AkD/KT
14291
5 October 2016

**SECTION 96(2) - MODIFICATION APPLICATION TO SSD 6484
45 PARK ROAD, BURWOOD - MLC BURWOOD SENIOR SCHOOL CENTRE**

Figure 5 – Proposed roof terrace and separation distances to adjoining dwellings
 Source: BVN Donovan Hill Architects

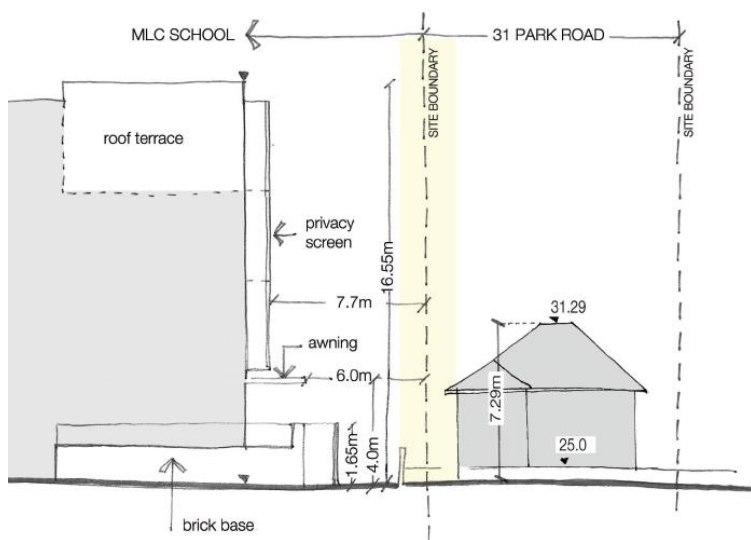
The proposed amendments to the Teaching and Learning Building will not alter the minimum 6 metre setback from the northern façade to the boundary (refer to **Figure 5**). The approved privacy screen on the upper levels will extend to the proposed additional storey. The privacy screen on the uppermost level will continue to prevent sightlines from the rooftop terraces, avoiding any privacy impacts to the neighbouring property. It is noted that the terraces will continue to be learning terraces, and will not be used for outdoor recreation.

A minimum separation of 7.7 metres from the privacy screen to the boundary will also be maintained (refer to **Figure 5**). Accordingly, despite the increased height, the Learning and Teaching Building will continue to provide a greater setback to the residential dwelling at 31 Park Road than the existing building and will maintain consistency with Burwood DCP 2013. Additionally, landscape screening along the boundary will continue to be provided for the purpose of creating a visual and acoustic buffer between the sites.
